HESPERIA BIG BOX RETAIL PROJECT

FINAL ENVIRONMENTAL IMPACT REPORT

PREPARED FOR
CITY OF HESPERIA
9700 Seventh Avenue
Hesperia, CA 92345

- DRAINAGE AREA BOUNDARY
- FLOW PATH
- SD STORM DRAIN
- PROPOSED FLOW DIRECTION ARROW
- X DRAINAGE AREA DESIGNATION
- X.XX AREA (AC)
- (1-1) NODE

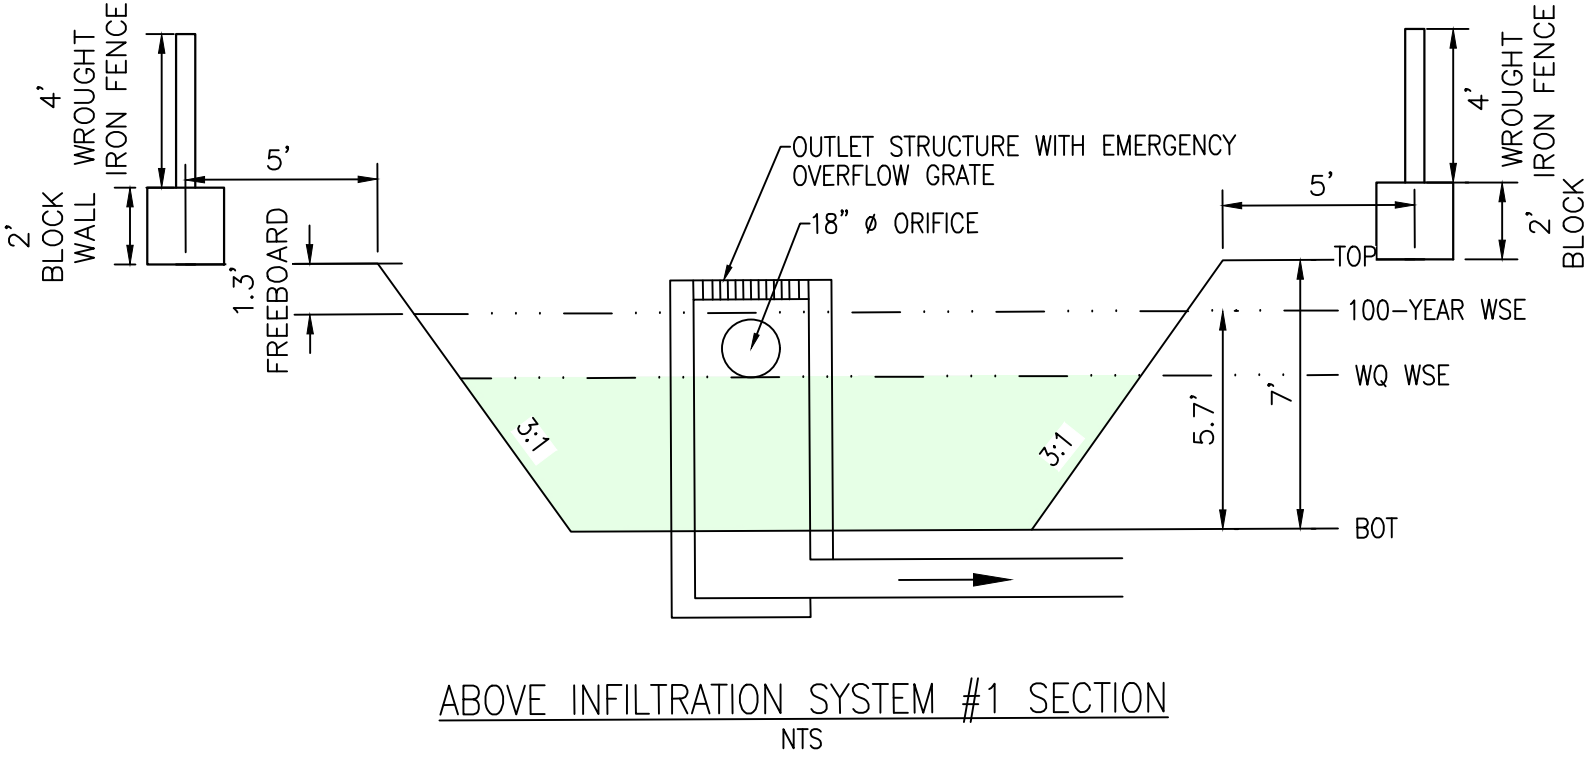
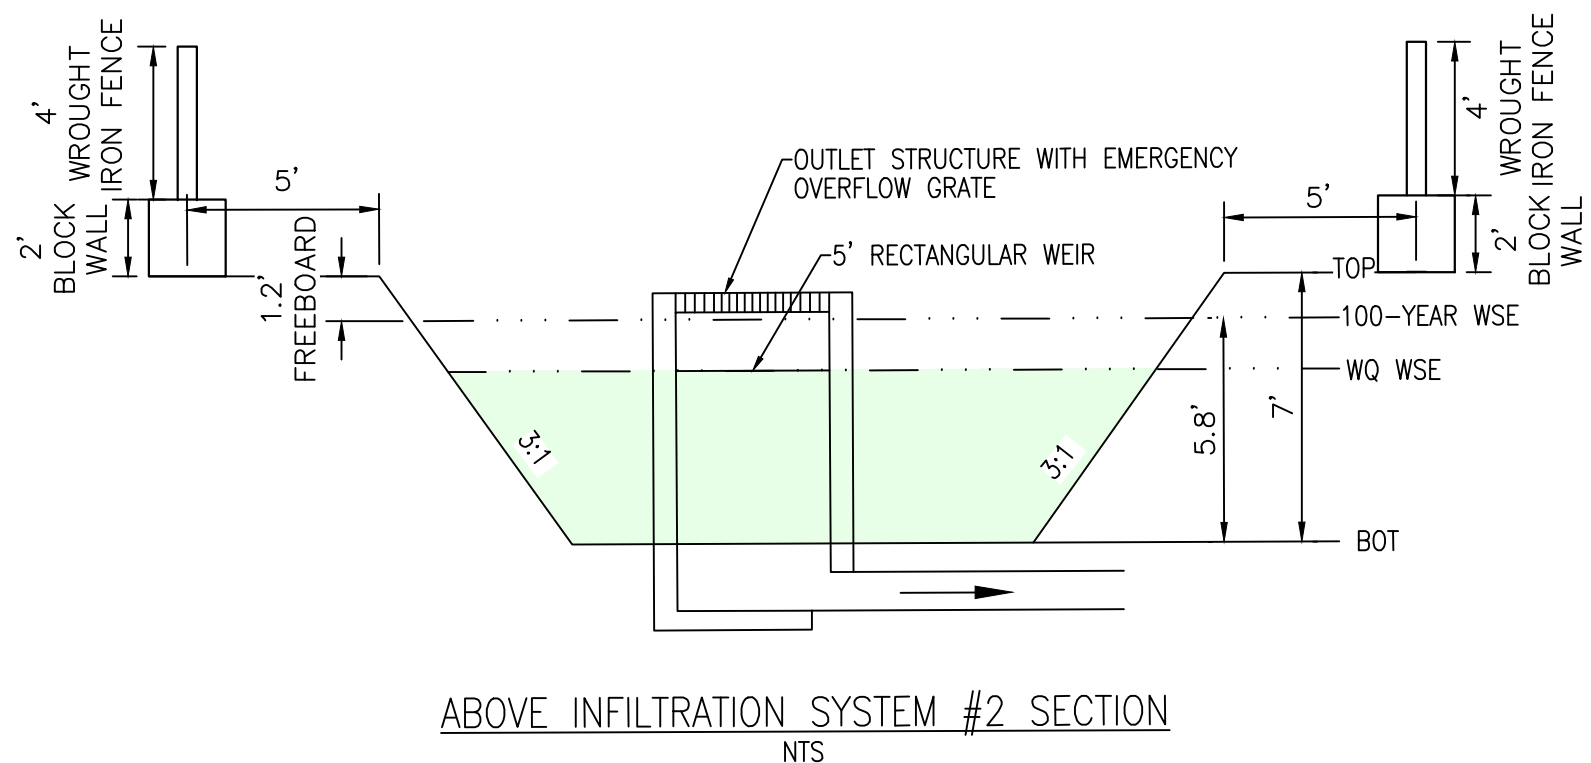
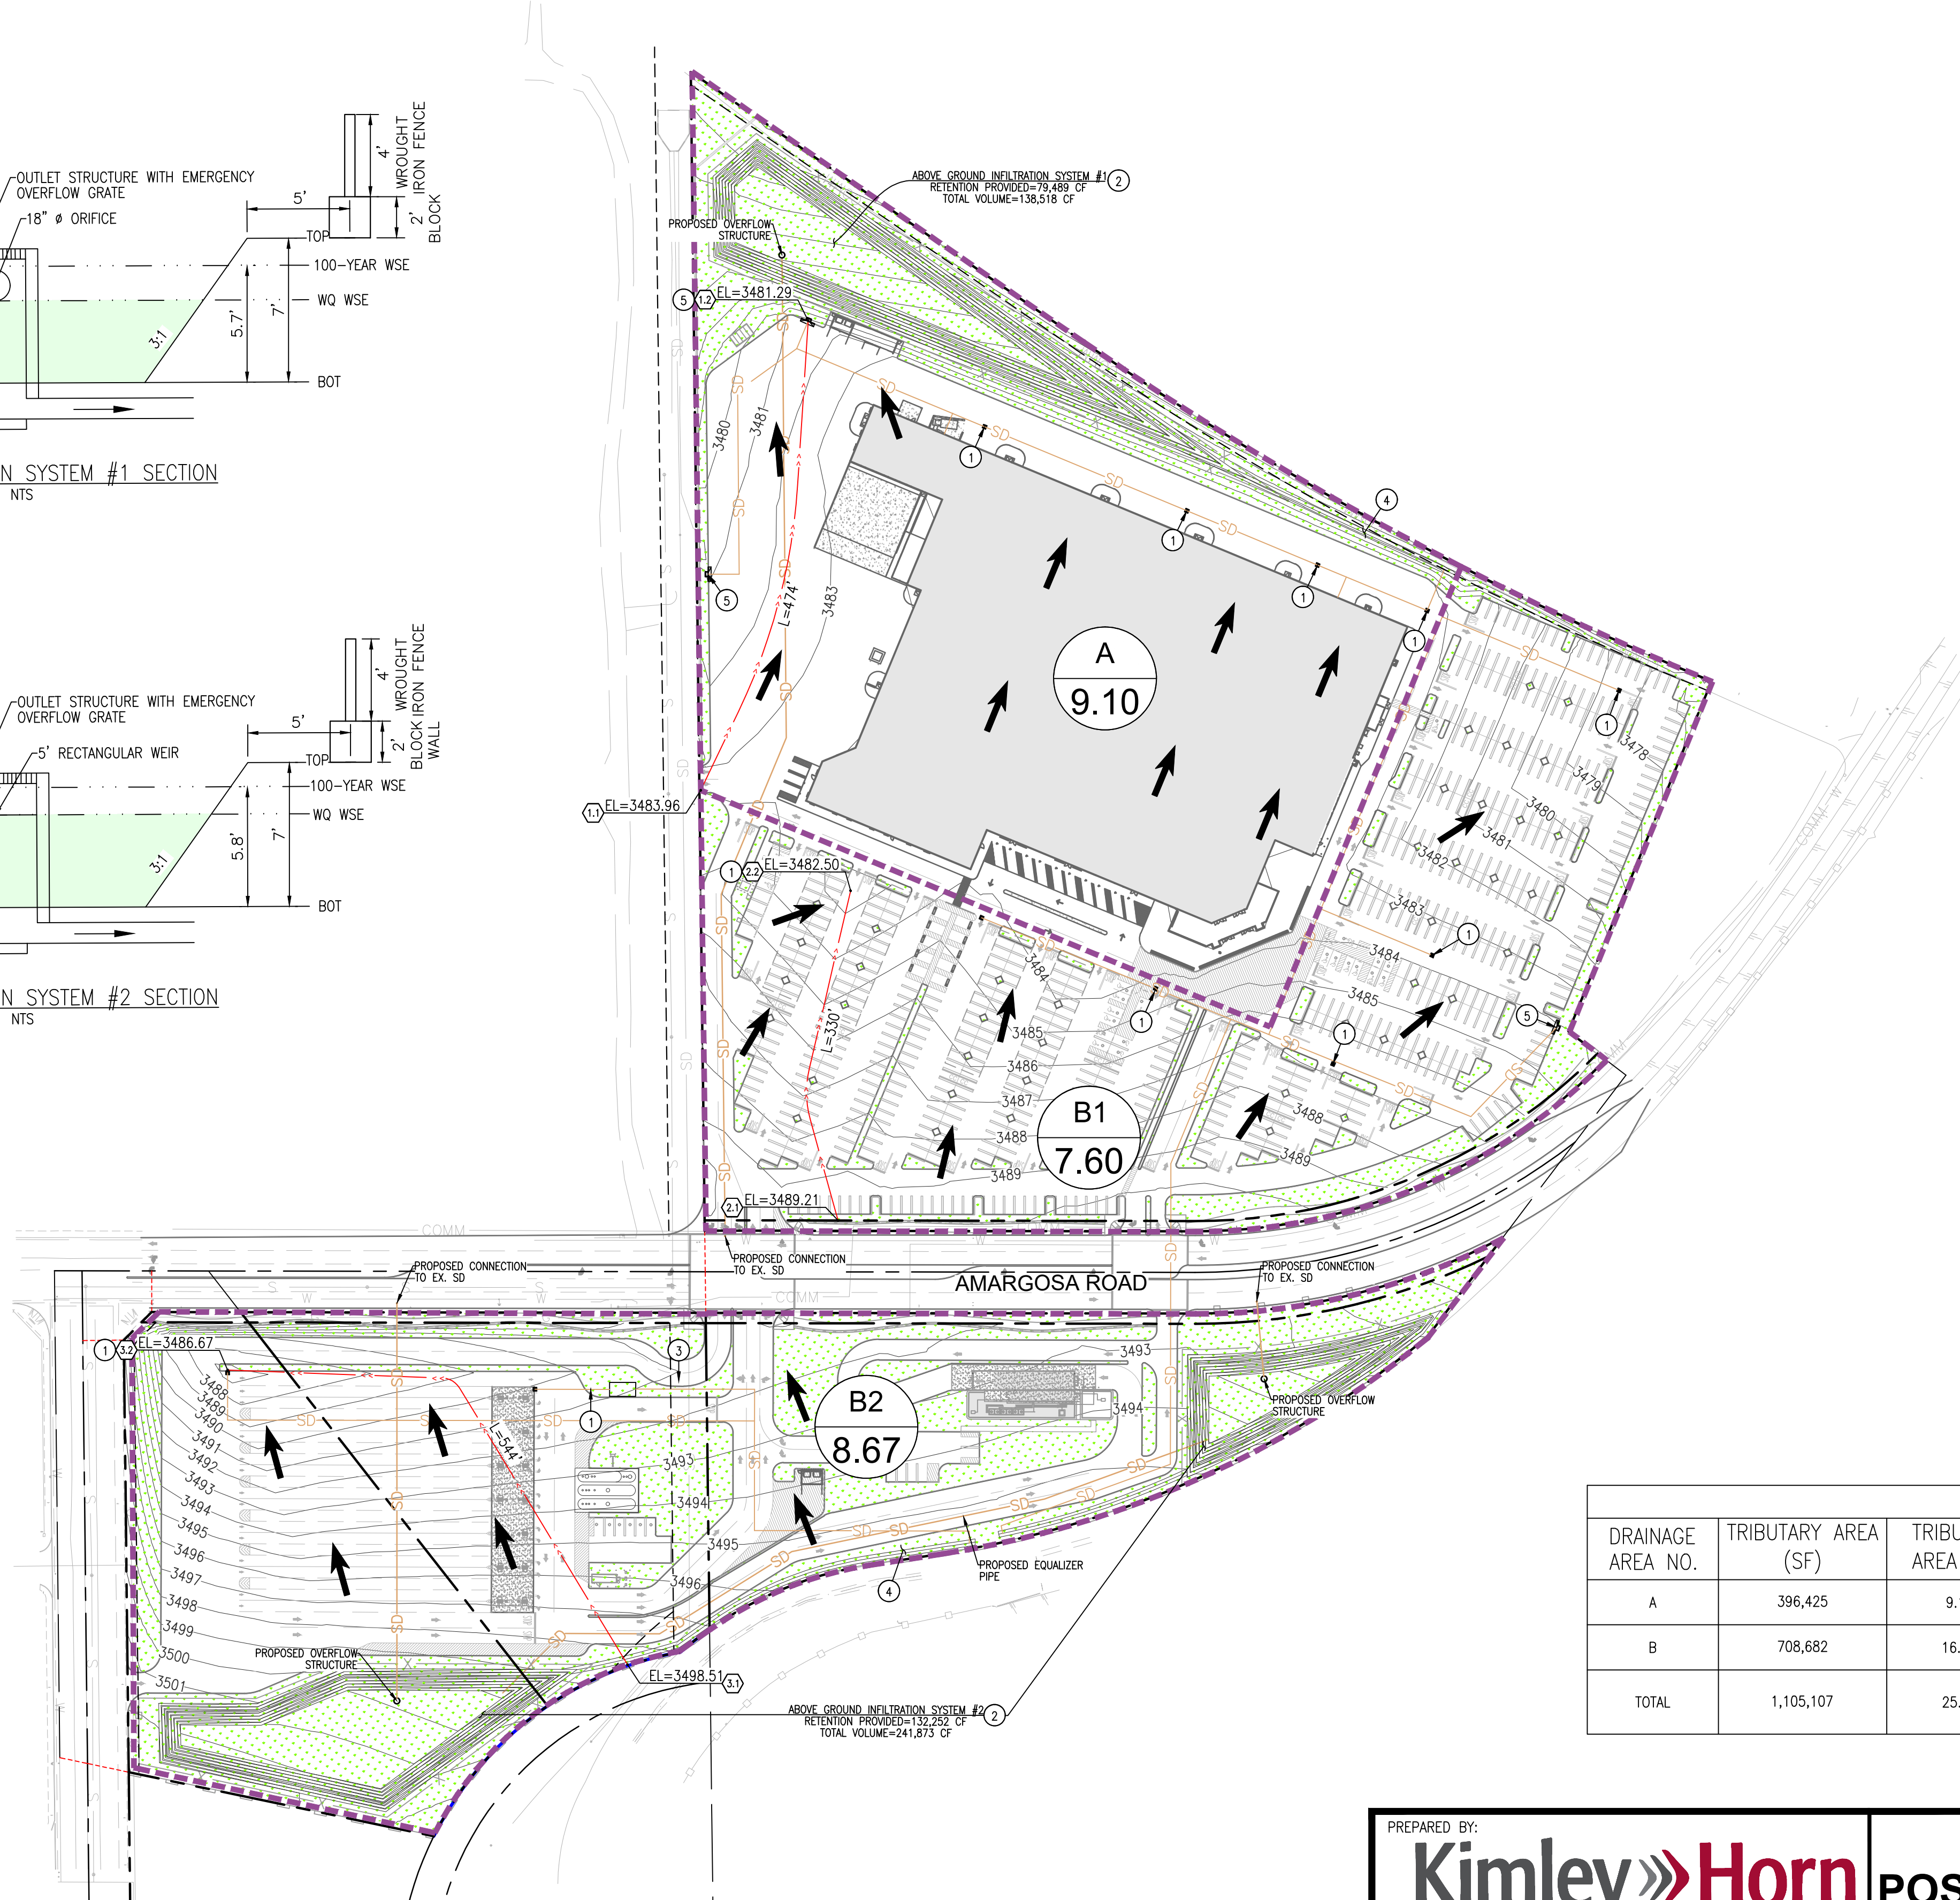
10. On the Post Development Hydrology Exhibit part of flow path 3.1 to 3.2 appears to be flowing uphill. Please verify this flow direction for accuracy.
11. Please verify the flow arrow shown on the Post Development Hydrology Exhibit, as it contradicts the grading contours.
12. The storm events analyzed do not appear to align with the San Bernardino Detention Pond Criteria. Please refer to the criteria to ensure compliance.
13. Please evaluate the detention ponds for 1-hour, 3-hour, 6-hour, and 24-hour storm events as required.
14. Detention pond routing was provided for only two of the three detention basins. Please include routing for the third basin or clarify why it was omitted.
15. Please illustrate where the proposed outflow (i.e., the portion not infiltrated) is directed for each of the detention basins. Clarify the downstream conveyance or discharge points as applicable.
